Technical Bulletin **TB 451 Issue 3**

Replacement of Connector Gas Elbow

Table 1 – Affected Products

Figure 1 – Elbow and location on product

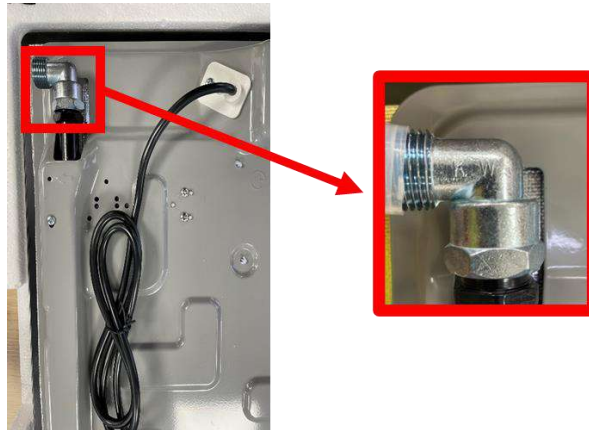
Belling have identified a potential issue with the **SILVER GAS INLET ELBOW CONNECTOR** on the gas hobs outlined in **Table 1**, when installed in holiday caravans, lodges, and park homes.

This elbow **must be** replaced, the location and type of elbow in question is shown in figure 1 below:

Figure 2 – Fitting connector examples

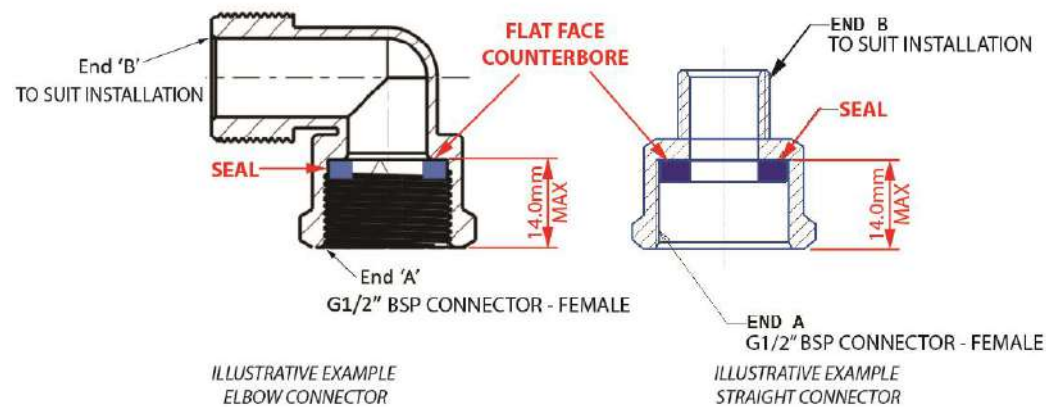
To eliminate this issue, **the silver gas connector** must be changed to a 1/2" BSP female and seal assembly, **End A**, as outlined in **figure 2** below. **End B** to suit installation. This can be either another elbow or a straight coupling, depending on pipe configuration.

It is imperative to check the following characteristics are met for "END A".

- **Hob connector 1/2" BSP thread**
- **Flat counterbore on seal mount face (refer to Figure 2)**
- **14.0mm MAXIMUM counterbore depth**

Figure 3 – Care Point "gap" illustration

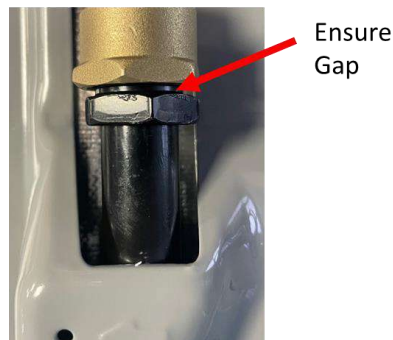
IMPORTANT CARE POINT - Ensure fitting "End A" is fully sealed to hob and check there is an observable gap between fitting flange as shown in figure 3.
